PARACHUTES AUSTRALIA

SERVICE BULLETIN No PA SB1001

SUBJECT: THINBACK AND SLIMPACK 2 RIPCORD HOUSING CLAMP

Image 1

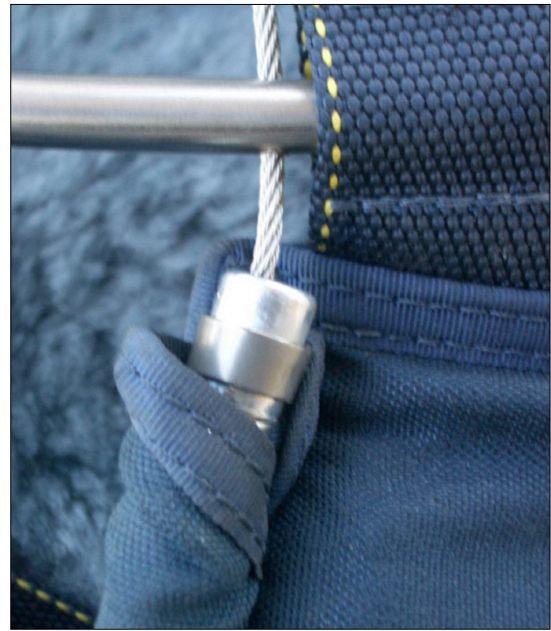
At a scheduled 6 monthly inspection and repack of a Thinback Harness and Container System it was found that excessive force was required to pull the ripcord.

Upon investigation it was discovered that the clamp that secures the ripcord housing located below the ripcord handle was loose allowing the housing to be extracted from its fabric cover when pulling the ripcord.

Subsequent investigation revealed that during manufacture the housing clamp had been incorrectly installed onto the housing immediately below the housing end cap (refer image 1). The diameter of the housing is smaller than the minimum effective clamp range and should be installed around the housing's end cap (refer image 2).

Thinback and Slimpack 2 harness and container systems contained within the above mentioned serial numbers that has a housing clamp installed “below” the housing end cap are to be removed from service and returned to the manufacturer for rectification.

Thinback and Slimpack 2 harness and container systems contained within the above mentioned serial numbers that has a housing clamp installed on the housing end cap are unaffected and can remain in service.
